Consultant Services Bulletin

News Bulletin No. 02-1, March 2002

CONSULTANT NEWS BULLETIN 02-1

Vertical Stopping Sight Distance (Supersedes article on page 1, CSB 00-2)

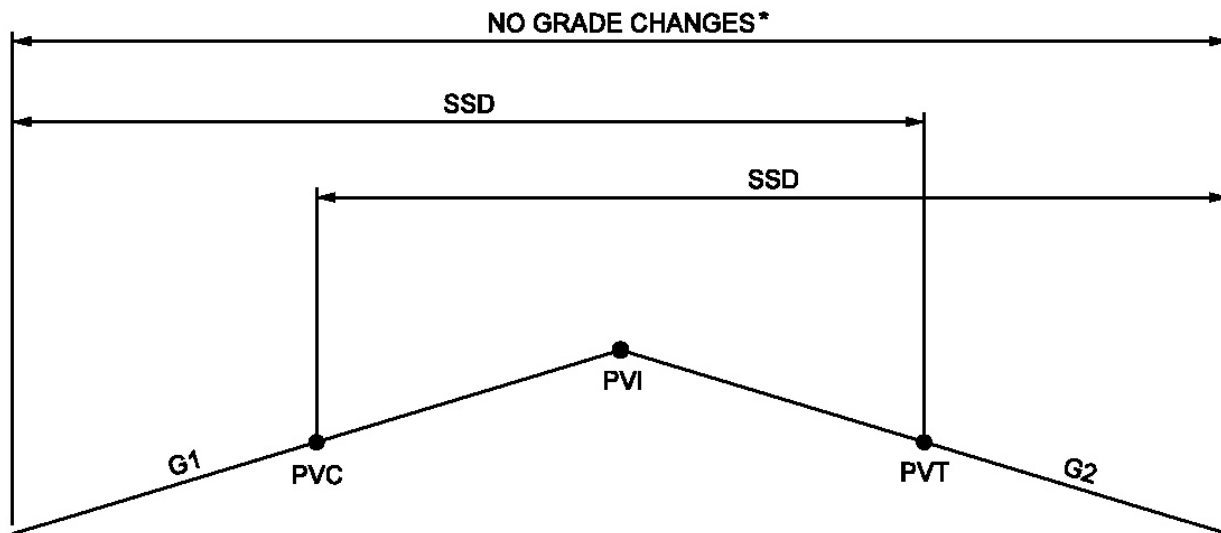
When the length of the vertical curve is equal to or greater than the stopping sight distance, a comparison of the K values (K required and K provided) will determine if the required stopping sight distance is provided.

When the length of the vertical curve is less than the stopping sight distance the designer may use any of the following methods to check the stopping sight distance:

1. Using K values

K provided \geq K required and there are no changes to G1 or G2 as shown below.

* No other vertical curves or angular breaks within this zone.

RIPRAP AND SODDING LIMITS WITH BARRIER TRANSITIONS ON APPROACH SLAB

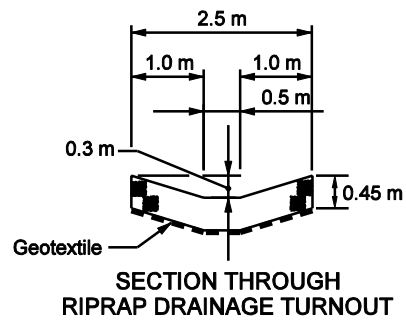
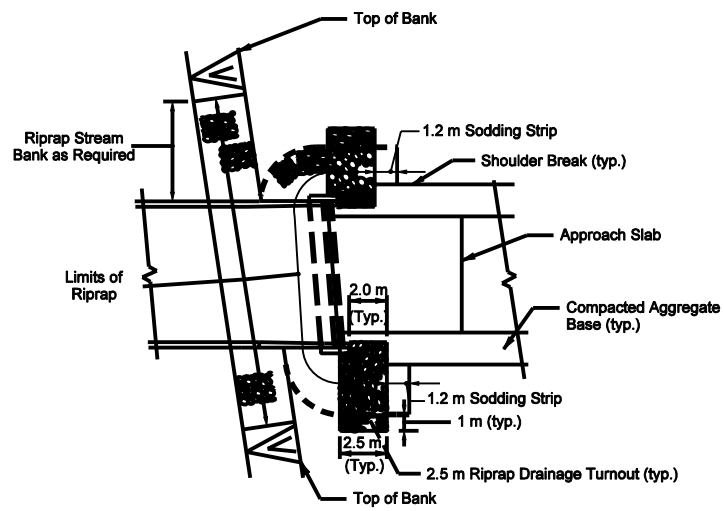
Recently, the Design Division surveyed the 6 districts regarding the riprap turnouts at bridge corners. As a result thereof, some minor modifications have been made to the details. The new details are contained in Appendix B. The details should be incorporated into all appropriate bridge projects to be let after July 1, 2002. The details in Appendix E of CSB 98-2 are superseded.
